Re: Technical Memorandum

Former Grimit Auto Repair and Service

1970 Seminary Avenue Oakland, California

(Fuel Leak Case No. RO0000413)

APPENDIX A

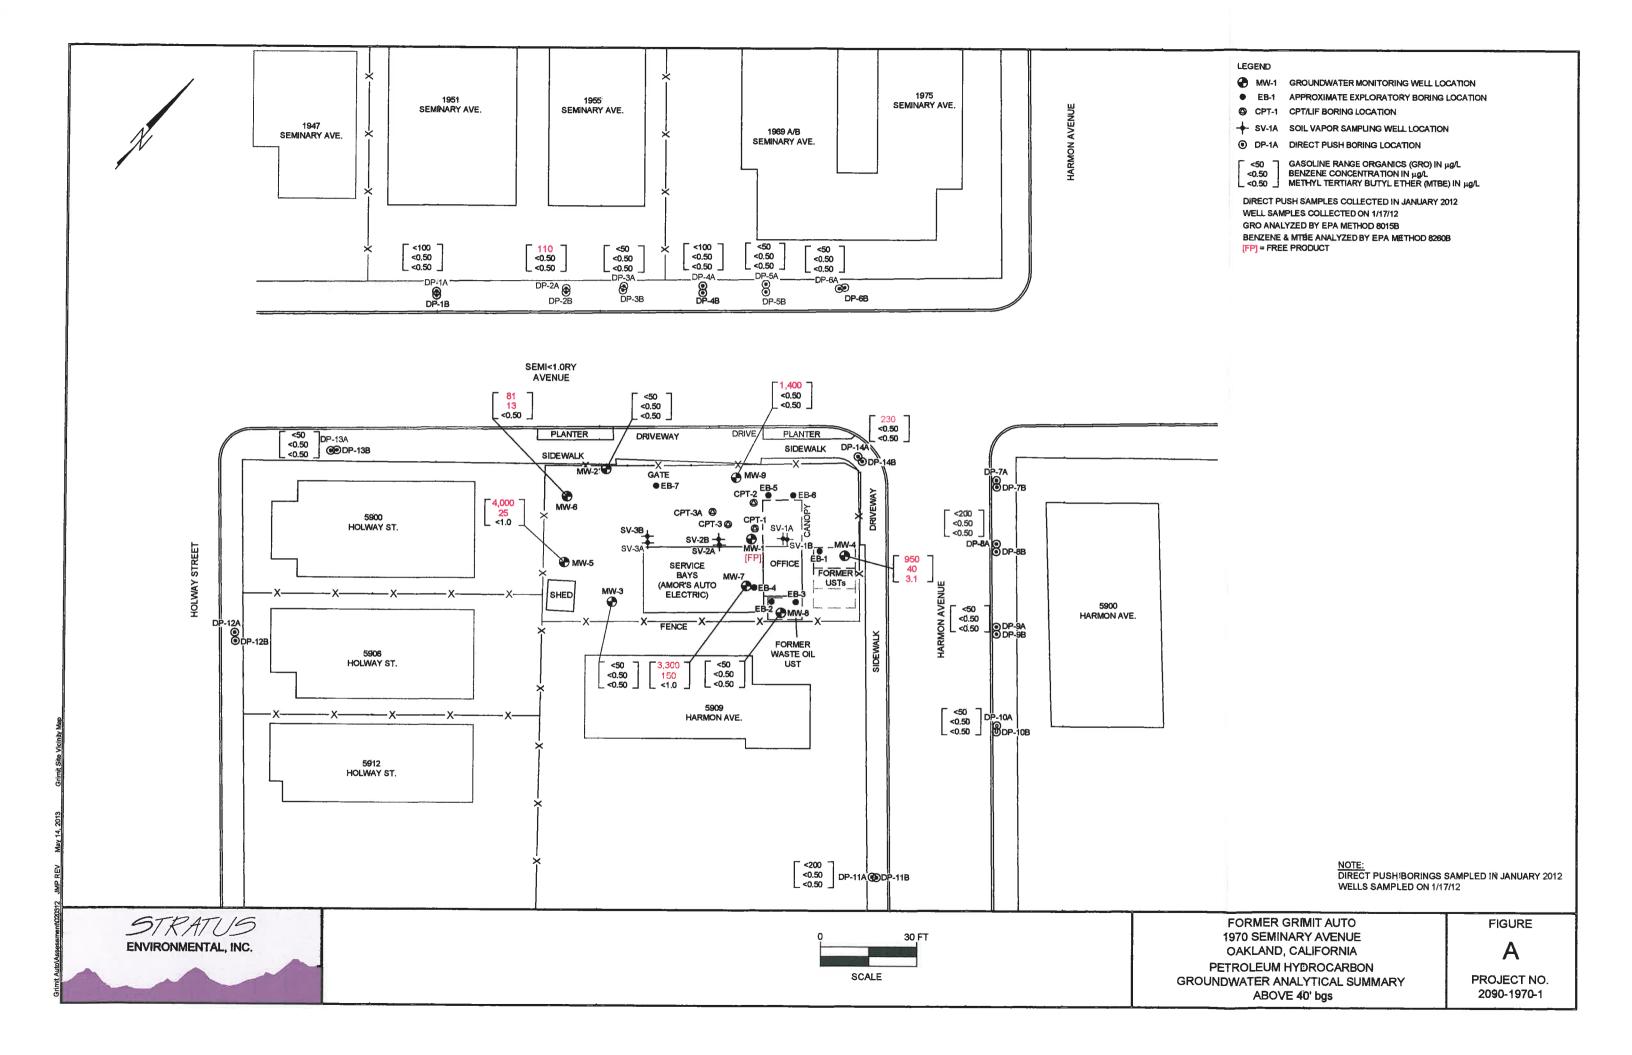
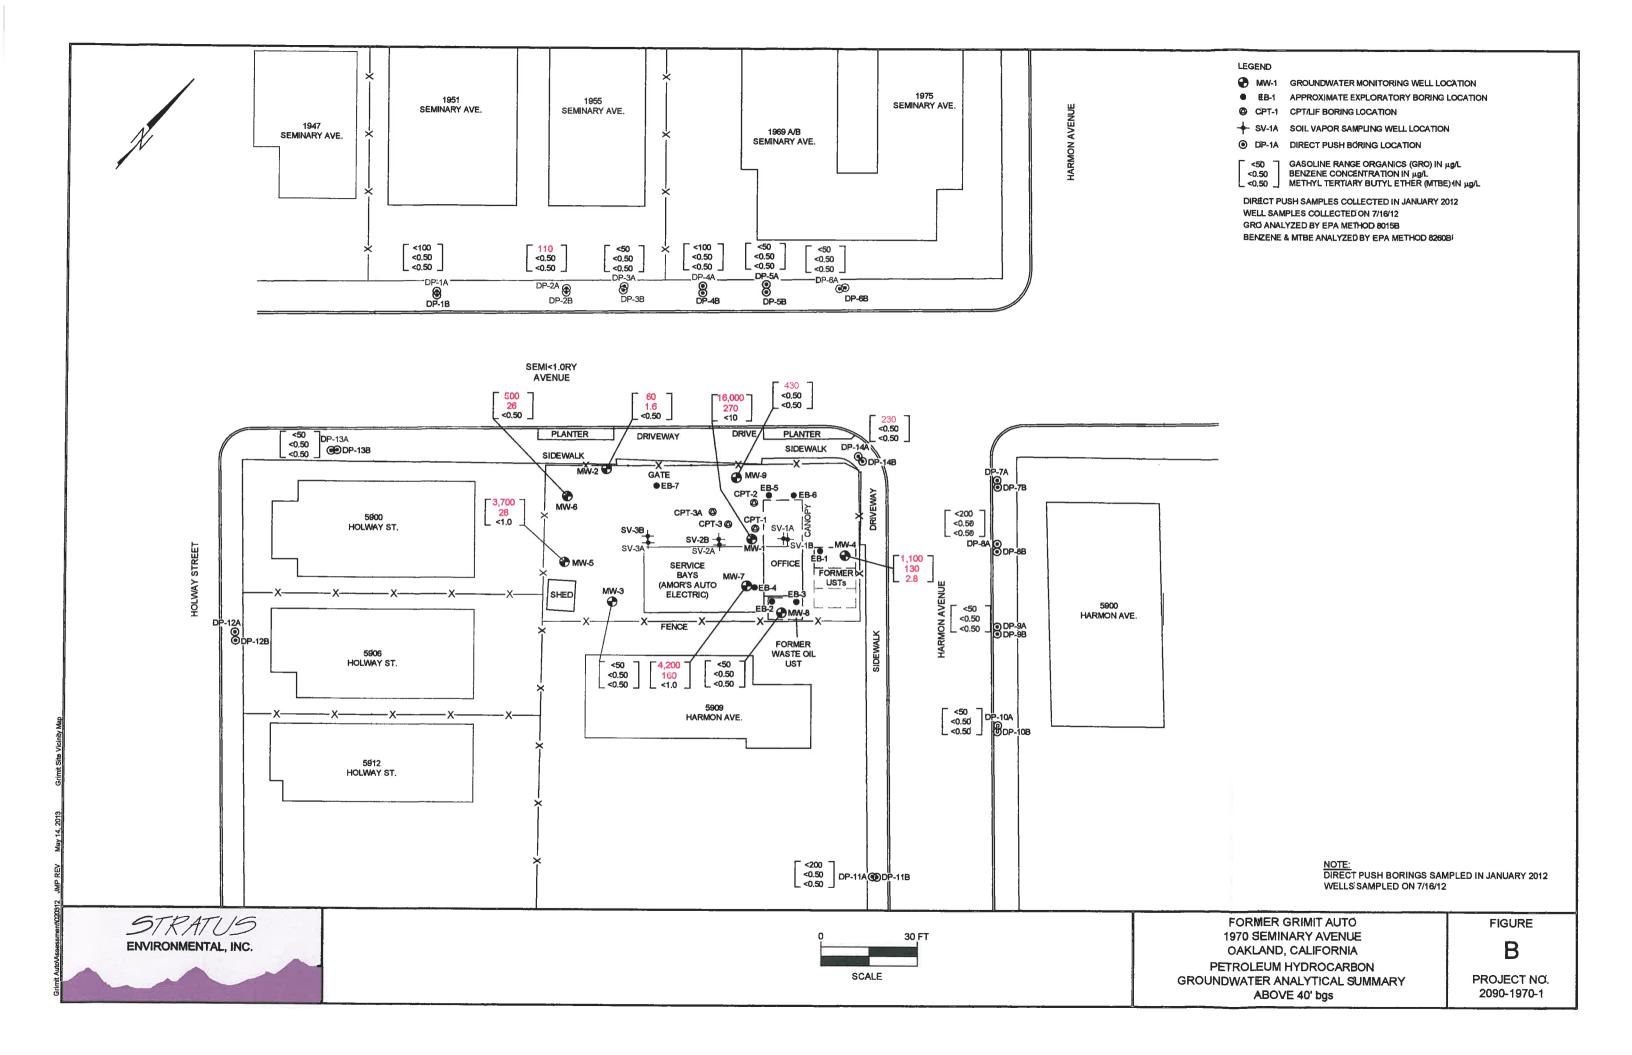
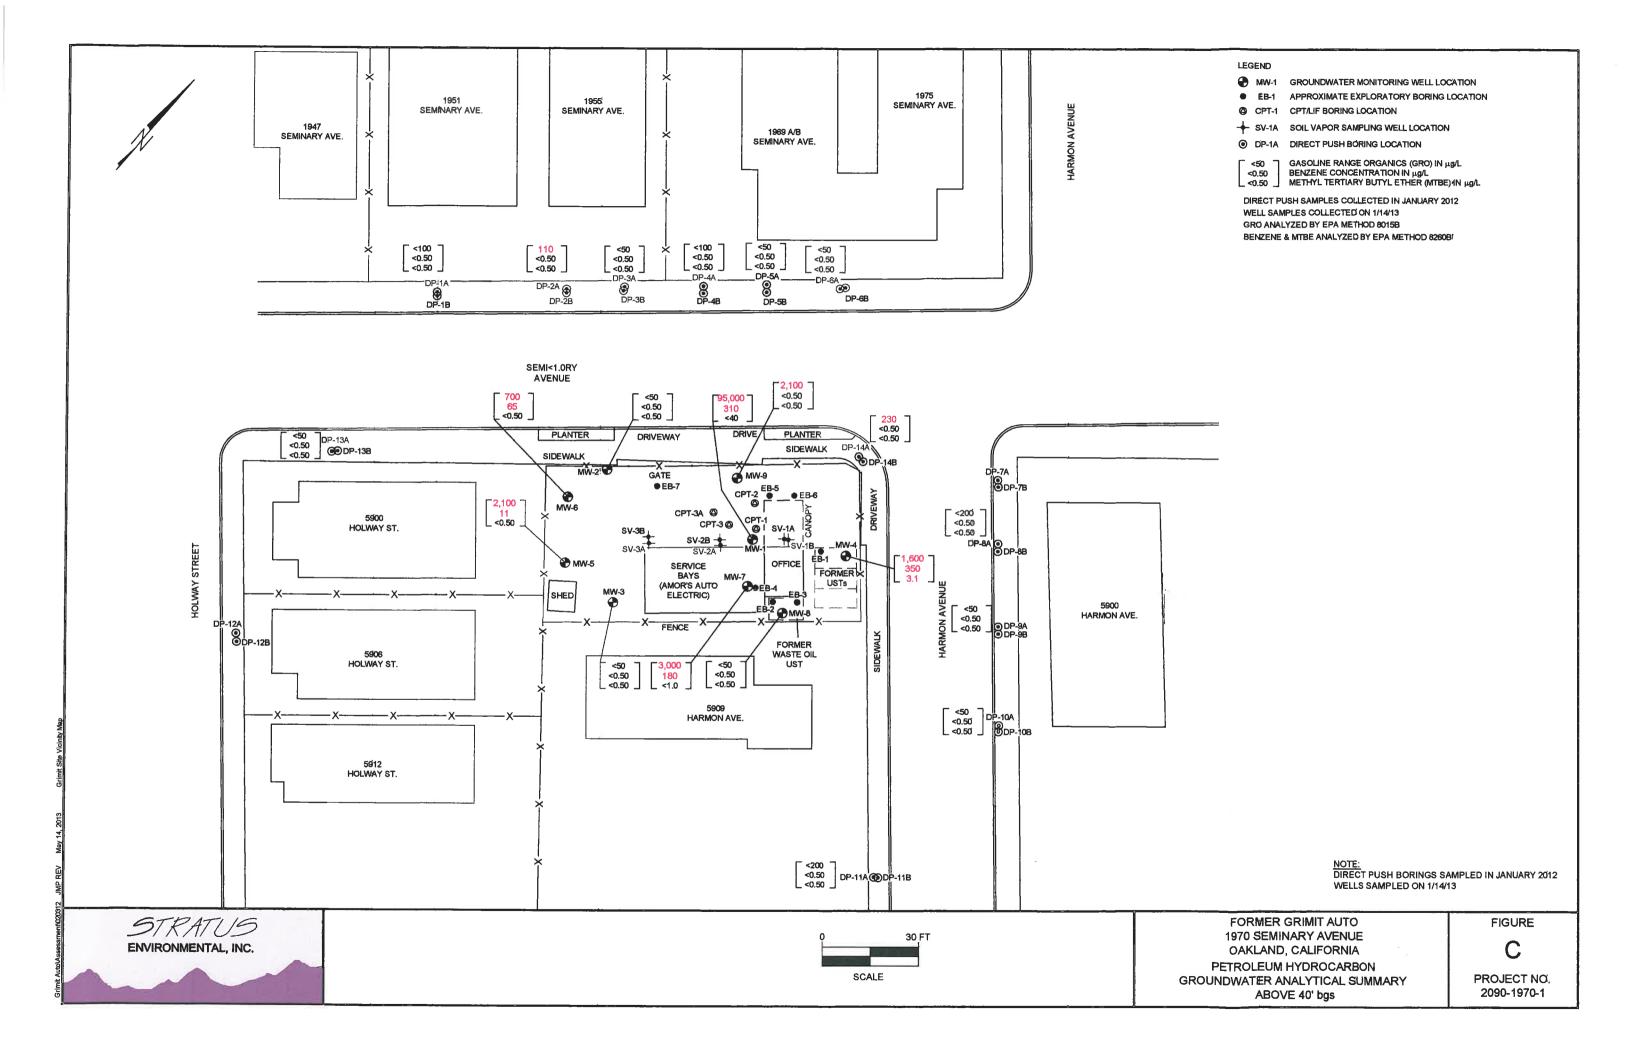
ACEHD expressed concern regarding groundwater elevation contour maps prepared by Stratus during quarterly/semi-annual groundwater monitoring and sampling. Currently, there are 9 groundwater monitoring wells located onsite, on a relatively small parcel of land (approximately 100 feet in length by 50 feet in width dimensions). The wells are constructed to various depths, with various screening intervals, but within what has been termed the 'upper water bearing interval' at the site. Despite the small size of the land parcel and flat topography of the area, water levels in the wells can vary widely, often up to 10 vertical feet. Given this condition, Stratus submits two groundwater elevation contour maps in quarterly/semi-annual groundwater monitoring reports, segregating data on a basis of well screen depth. Often, groundwater flow on the two contour maps are depicted in different directions, and despite many years of groundwater monitoring and sampling, ACEHD is concerned that the groundwater flow direction beneath the property is poorly understood.

Instead of evaluating shallow groundwater flow direction using groundwater elevation contour maps at the subject property, we believe that more useful information can be obtained by reviewing petroleum hydrocarbon groundwater analytical data reported from the site's network of monitoring wells. Stratus has attached Figures A through C that summarize petroleum hydrocarbon concentrations in the site's monitoring wells during the first and third quarters of 2012 and the first quarter 2013, respectively (see Appendix A). Also shown on these figures are the results of direct push groundwater sampling performed in January 2012 (the same data is shown on all figures), and the locations of the former underground storage tanks in the eastern property corner. A review of the available data illustrates that three wells located near the western property corner (MW-2, MW-5, and MW-6), approximately 80 feet from the former USTs are impacted with petroleum hydrocarbons (intermittent impact observed at well MW-2). In addition, petroleum hydrocarbons were detected at one offsite boring location located west-northwest of the former USTs (DP-2).

In our opinion, groundwater flow beneath the property is not in a single, uniform direction. However, based on the available data, petroleum hydrocarbons appear to have migrated further from the former USTs in the west, northwest, and southwest directions; given this condition, we believe that northwest, west, and southwest are the predominant groundwater flow directions in the site vicinity. If this is the case, shallow groundwater flow would be towards San Francisco Bay.

APPENDIX B

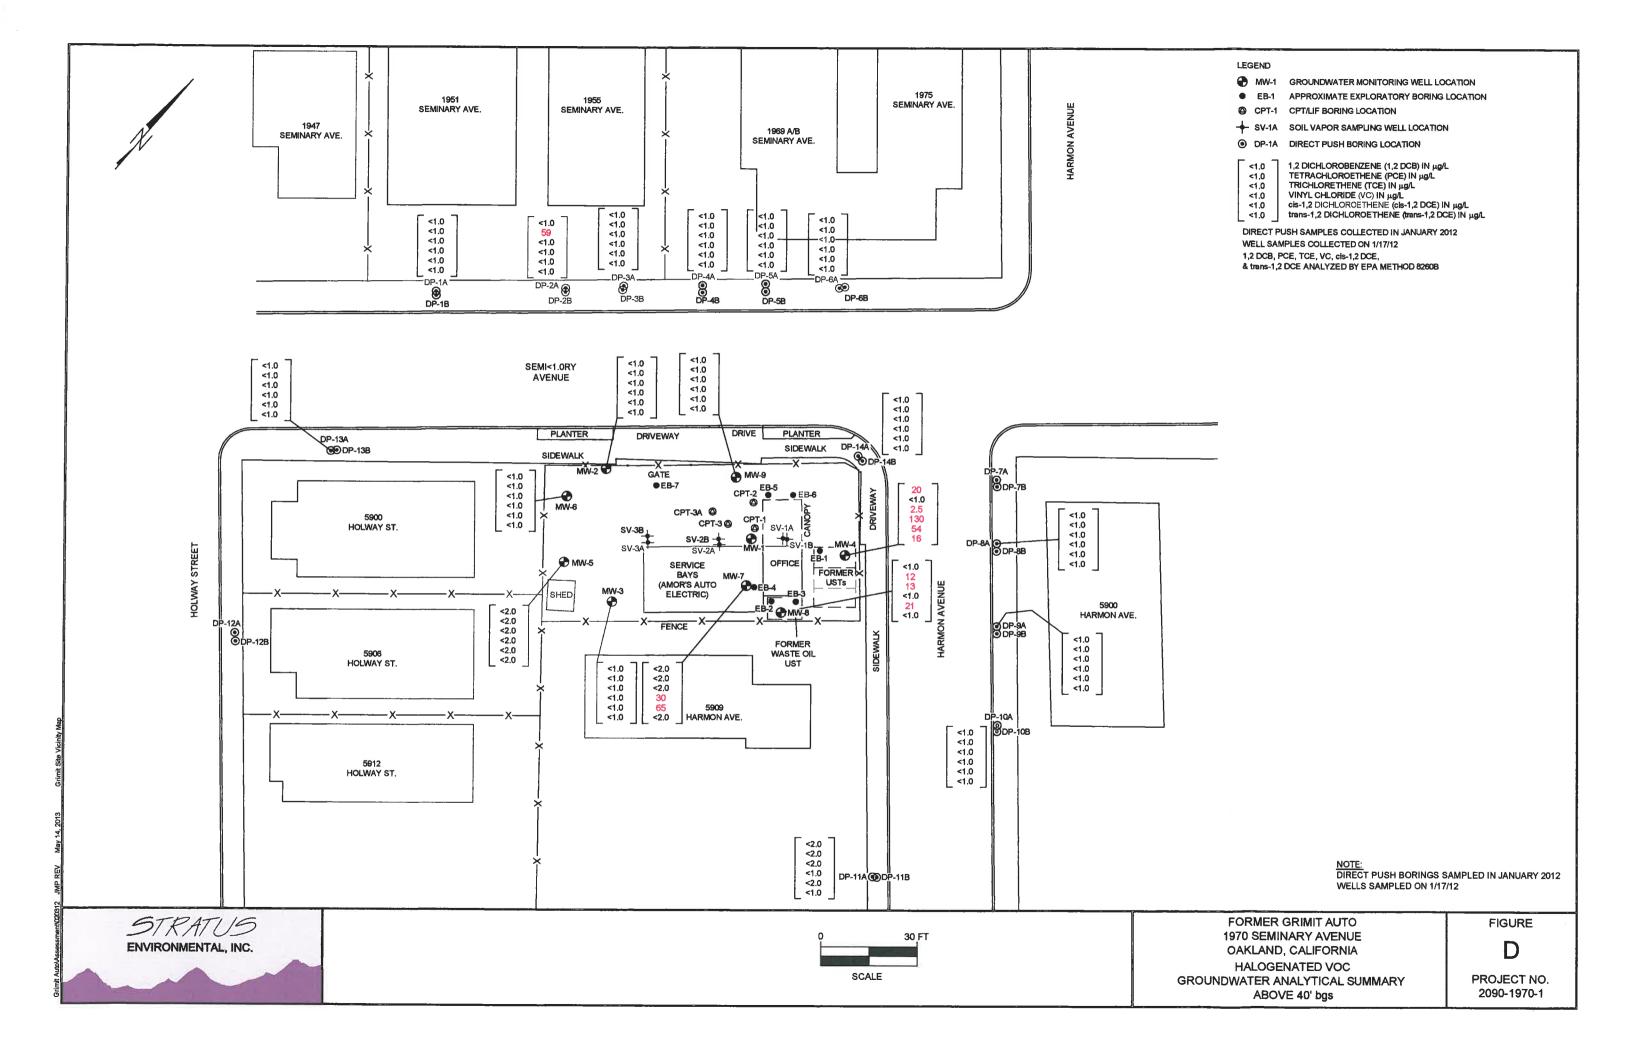
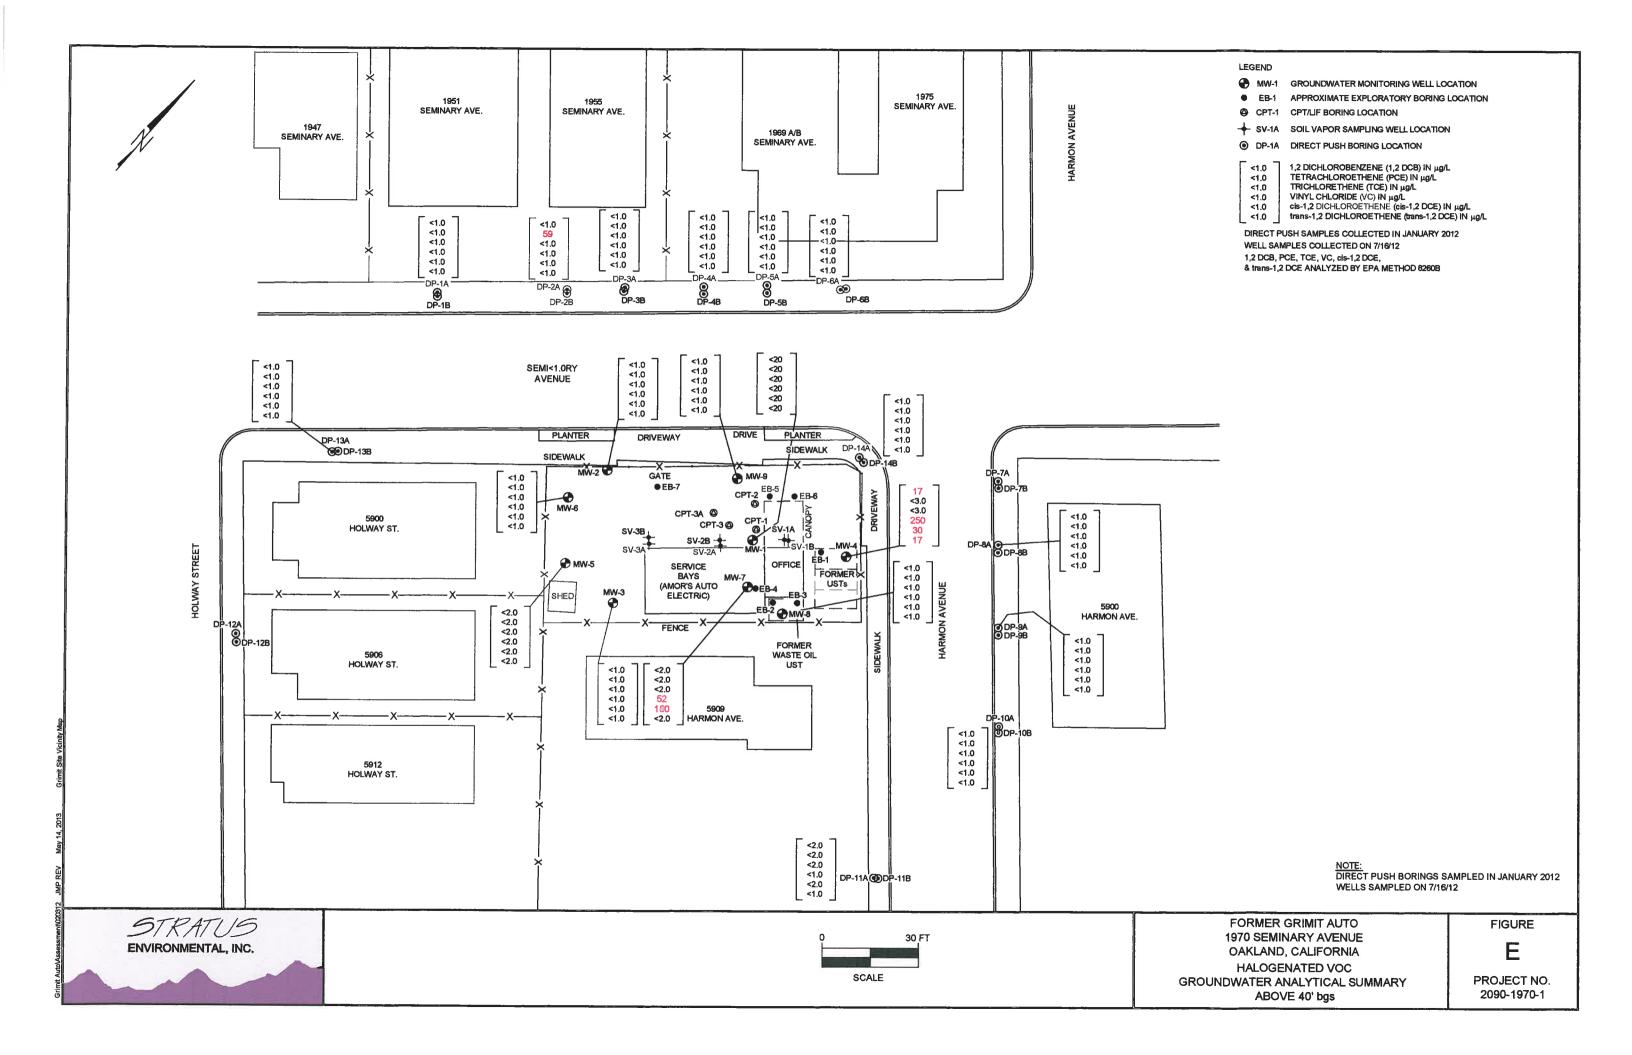
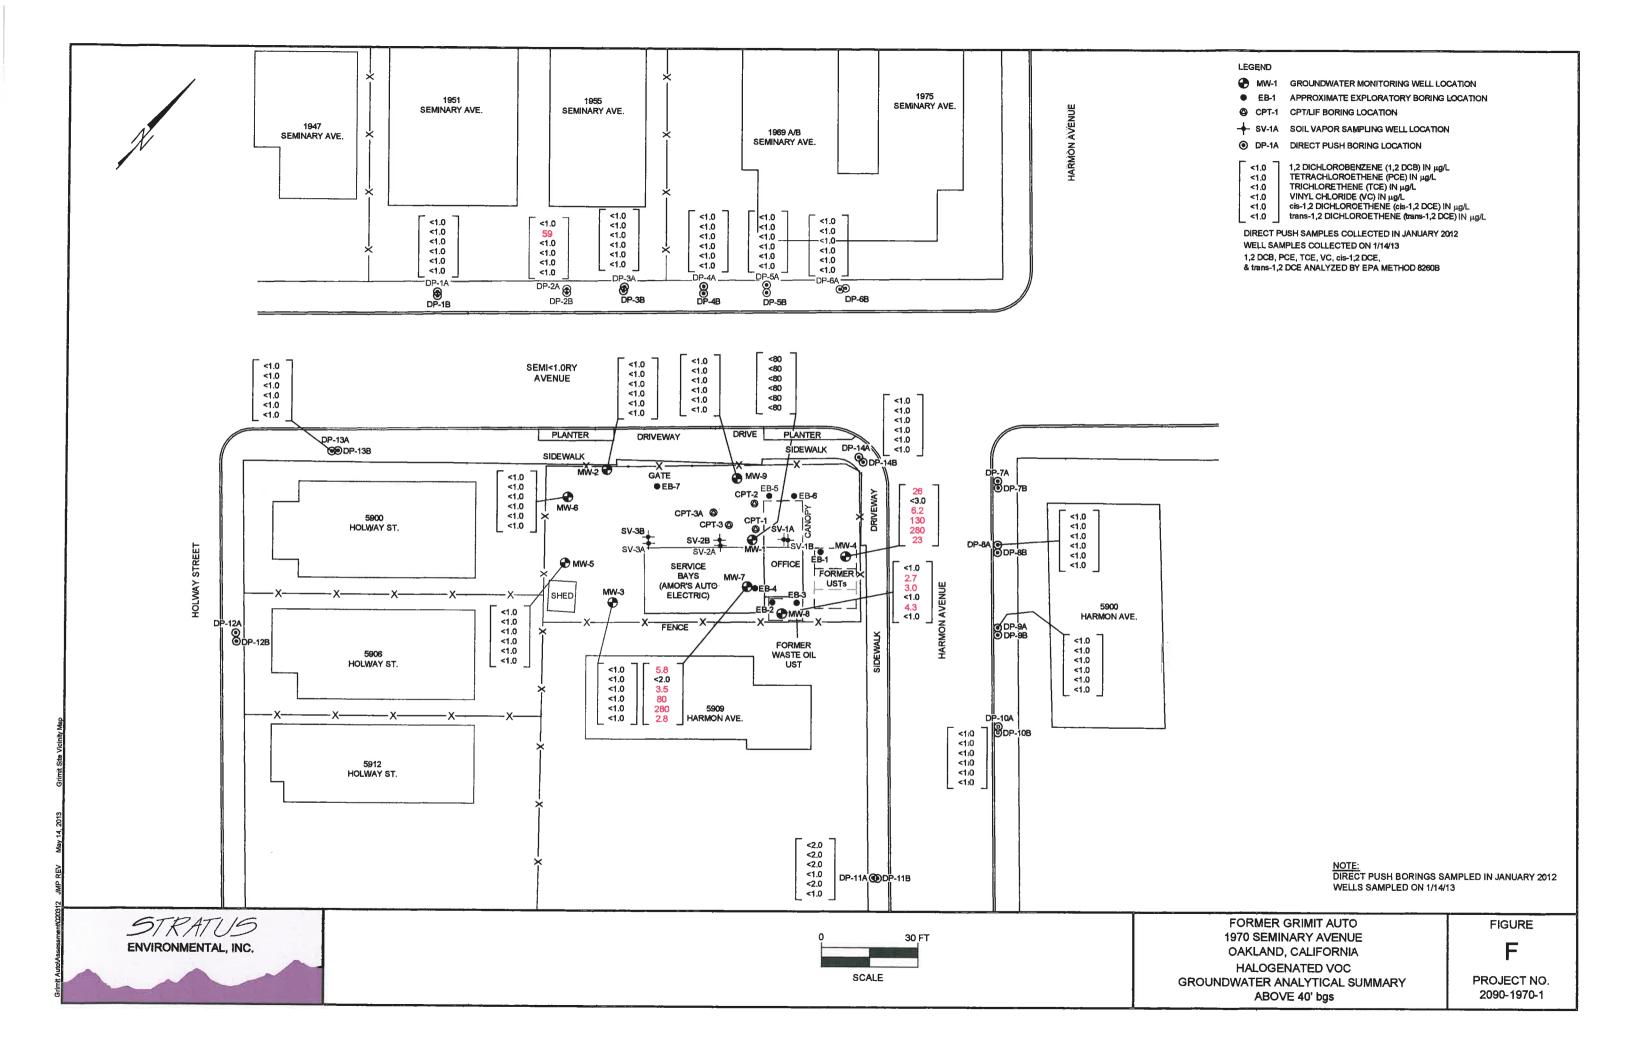
In addition to petroleum hydrocarbon impact to the subsurface, VOCs are present at the site. In shallow groundwater, VOCs are noted in the eastern portion of the property (see Figures D through F in Appendix B). Of particular concern, tetrachloroethene (PCE) has been detected beyond the 'upper water bearing interval', in samples collected in January 2012, and no monitoring wells are in place to allow for regular assessment of deeper VOC impact.

Stratus acknowledges that the presence of PCE in groundwater, in particular beyond the 'upper water bearing interval', is problematic. At this time, it is our opinion that remediating shallow contaminants (both petroleum hydrocarbons and VOCs) should be the highest priority work for the site, as this should both remove contaminant mass (including free product) from the subsurface, and reduce the future likelihood of vertical contaminant transport (in particular PCE).
